Licence Number	L5415/1988/9
Licence Holder	BHP Billiton Iron Ore Pty Ltd
ACN	008 700 981
File Number:	DER2013/000900
Premises	Wheelarra Hill (Jimblebar) Iron Ore Mine Tenements L52/108, L52/109, L52/163, I126948, M266SA and ML244SA NEWMAN WA 6753
Date of Amendment	19 February 2019

Amendment

Amendment Notice

This notice is limited to an amendment to L5415/1988/9 for existing categories 5, 6 and 64 and the addition of a new category, Category 12.

Figure 1: Comparison of a 6089 MKII Superior Crusher to a 7089 MK II Superior Crusher

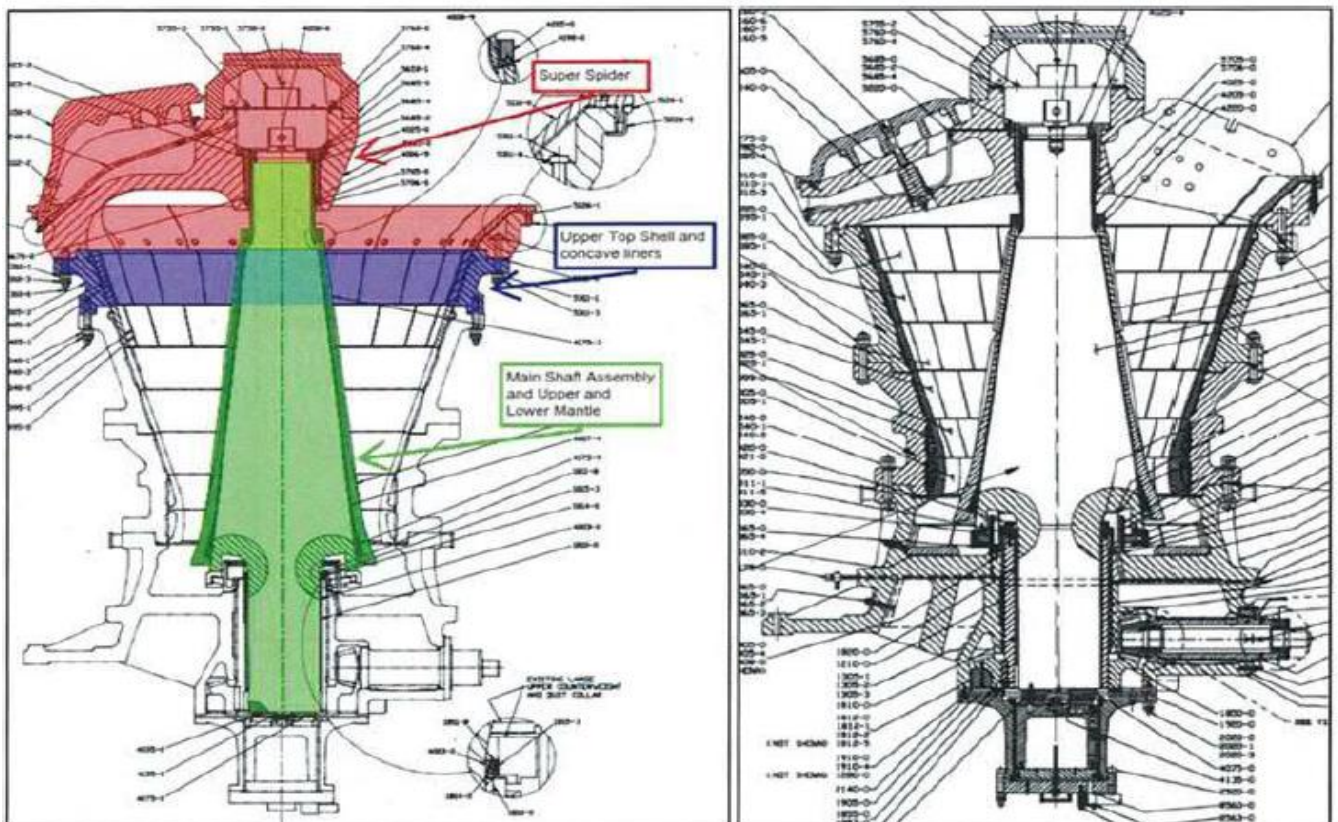
- An upgrade to Primary Crusher 3 from a 6089 MKII Superior Crusher to a 7089 MKII Superior Crusher, this upgrade involves:
 - a longer main shaft;
 - A super spider featuring high arching arms that allows larger particles to enter the crushing chamber;
 - An upper top shell; and
 - An upgraded drive motor from 630 kW to 750kW.

Figure 1 below shows a 6089 MKII Superior Crusher to a 7089 MK II superior Crusher, highlighting the main components of the upgrade (excluding the drive upgrade).
